City of
GREENFIELD, MASSACHUSETTS

Maintenance Dredging of Upper Glen Reservoir
Contract DPW 19-04
Addendum #2

August 27, 2018

MAINTENANCE DREDGING PLAN

4 SEDIMENT AND DEWATERING AREA CONFIGURATION

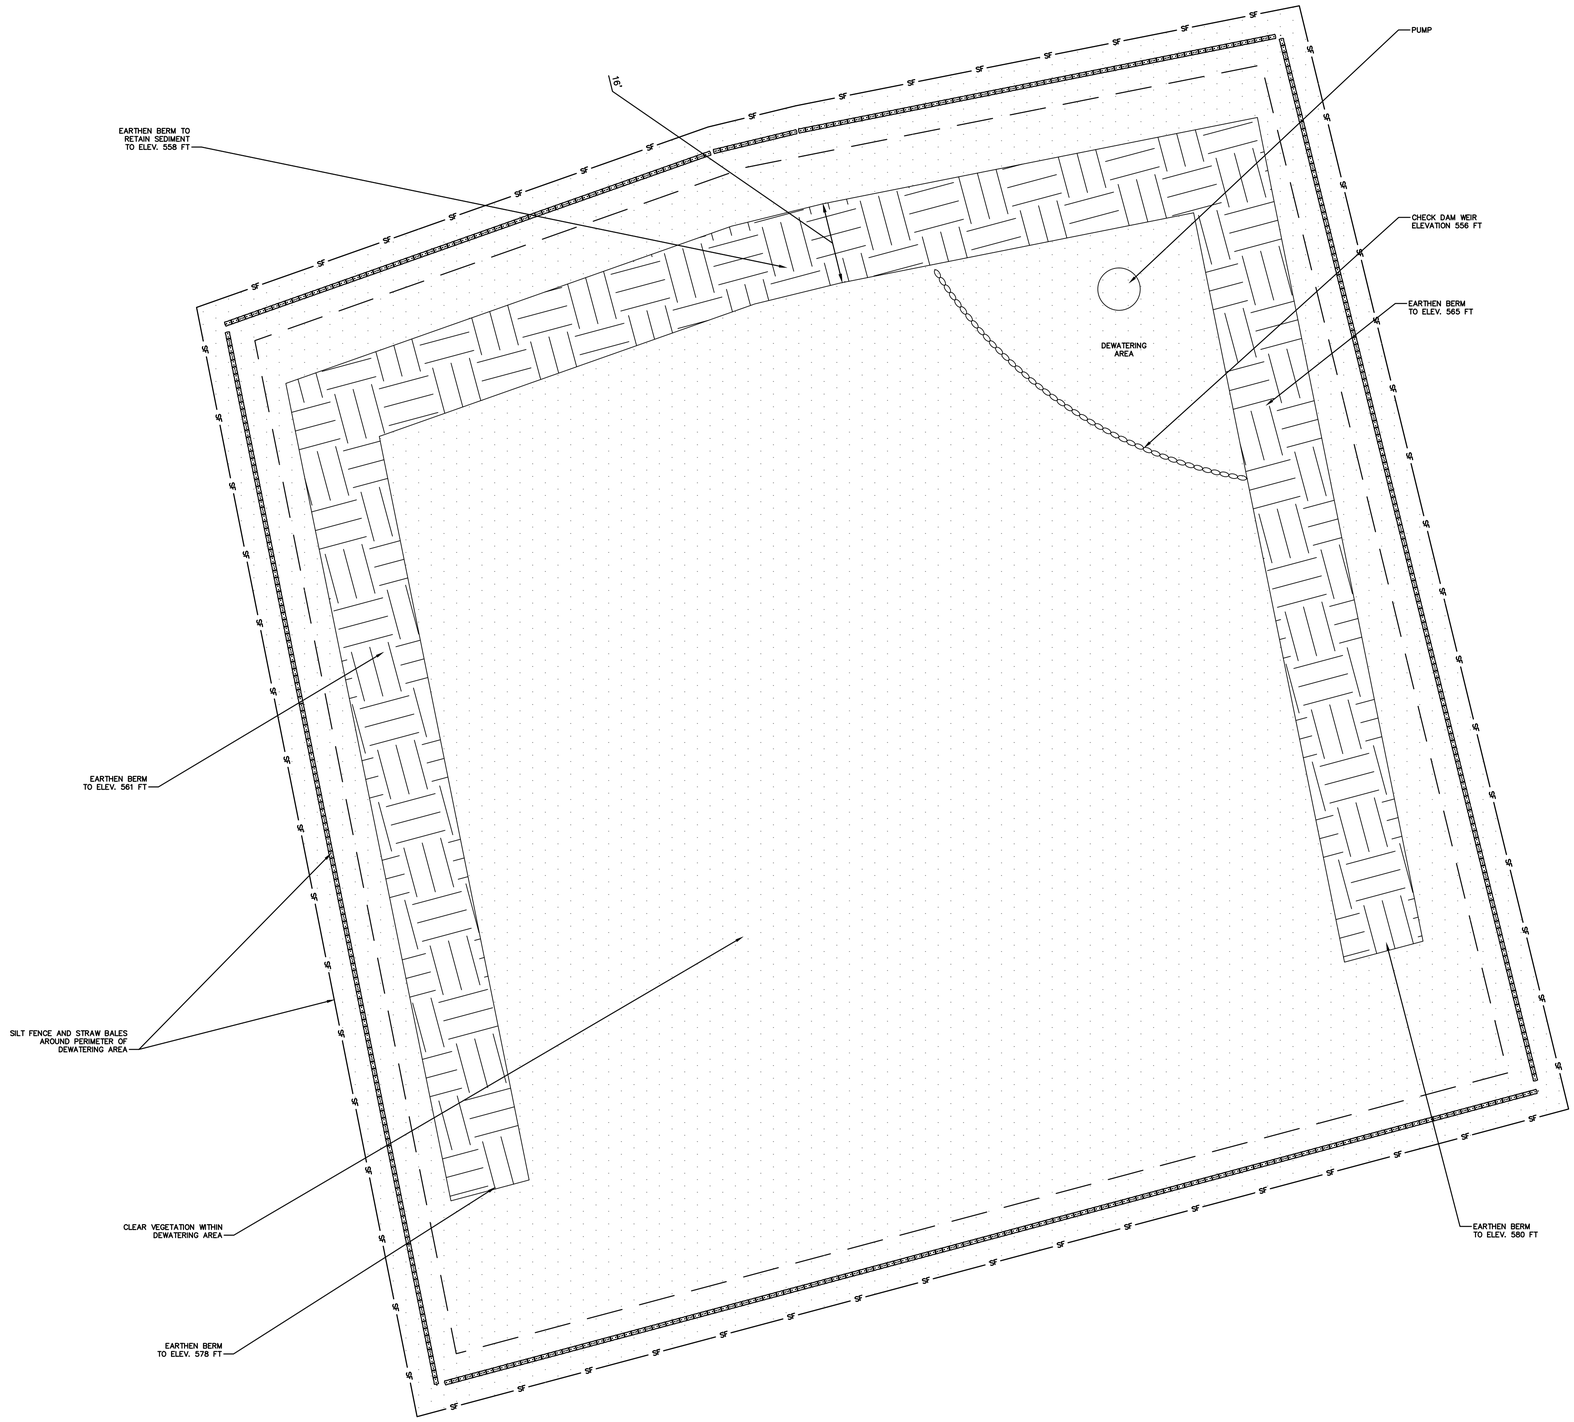
2. Will the silt fence and haybales for the dewatering area remain in place for the duration or will removal be required yearly?

Answer: *The silt fence and haybales can remain in place for the duration of the project but must be maintained during the duration of the project.*
